2017-10-24

## Purpose for Service Bulletin

The production change was corrected as of September 13, 2017.

**Figure 1. Primary Drive Components (Typical)**

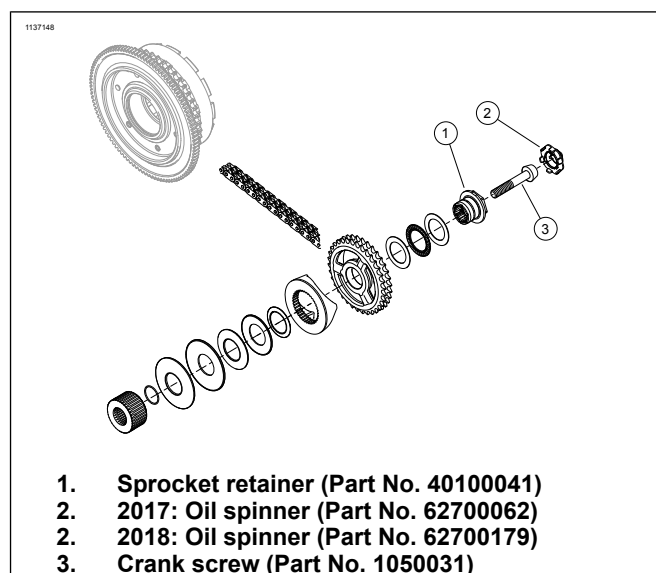
Unusual clicking sounds coming from primary.

1. Remove primary cover. See the service manual.
  - a. Determine the source of the sound.
  - b. If the spinner has lost retention, inspect the compensator assembly for wear and service as needed.

2. Refer to Figure 1. Determine that the oil spinner (2) has lost retention.
3. Upon assembly, replace crank screw (3) and both sprocket retainer and appropriate spinner for the model year.
4. Thoroughly clean any residual plastic from the primary chaincase.
5. Assemble with **new** primary cover gasket. See the service manual.
